Access Compliance Report

Public Rights-of-Way

Intersection ID: 28304	Main Street: LANCASTER_HY	Cross Street: JOHNSTON_RD	Location: NW
ADA ID: D745EF9CE61E	Ramp Type: Perp	Initial Pass/Fail: Fail	Overall Compliance: No
		Severity Score: 12.5

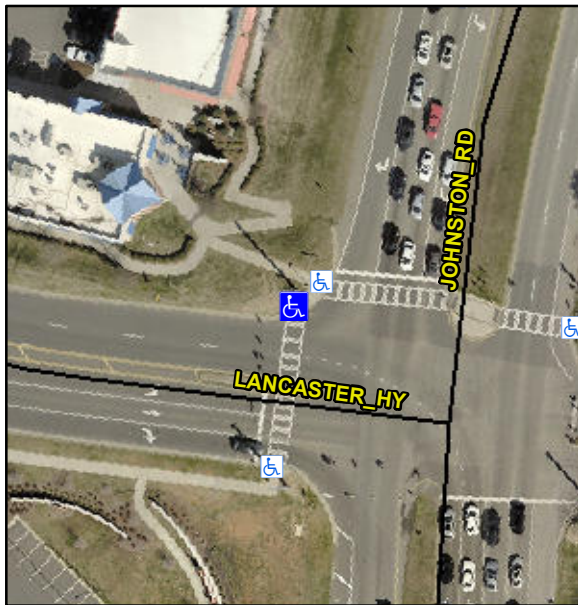
Not Found, R304.5.3

Compliance	Description	Data	Compliance	Description	Data
N/A	Ramp Length (in)	63.0	Yes	Ramp Slope (%)	8.1
Yes	Ramp Width (in)	53.0	No	Ramp XSlope (%)	5.7
N/A	Flare Type LT	N/A	N/A	Flare Type RT	N/A
N/A	Flare Slope LT (%)	N/A	N/A	Flare Slope RT (%)	N/A
N/A	Flare Traversable LT?	N/A	N/A	Flare Traversable RT?	N/A
N/A	Landing Length (in)	N/A	N/A	DWS Provided?	N/A
N/A	Landing Width (in)	N/A	N/A	DWS Contrast?	N/A
N/A	Landing Slope (%)	N/A	N/A	DWS Length (in)	N/A
N/A	Landing X Slope (%)	N/A	N/A	DWS Full Width?	N/A
N/A	Landing Curb? (Y/N)	N/A	N/A	DWS Offset (in)	N/A
N/A	Shared Landing?	N/A			
N/A	Gutter Ponding?	N/A	N/A	Gutter Slope (%)	N/A
N/A	Gutter Lip Ht (in)	N/A	N/A	Gutter X Slope (%)	N/A
N/A	Painted X Walk1?	Yes	N/A	Painted X Walk2?	N/A
	X Walk 1 Direction	To SW		X Walk 2 Direction	N/A
N/A	X Walk 1 Width (in)	105.0	N/A	X Walk 2 Width (in)	N/A
	X Walk 1 Slope (%)	4.7		X Walk 2 Slope (%)	N/A
	X Walk 1 X Slope (%)	0.1		X Walk 2 X Slope (%)	N/A

Remove & Replace Entire Ramp.
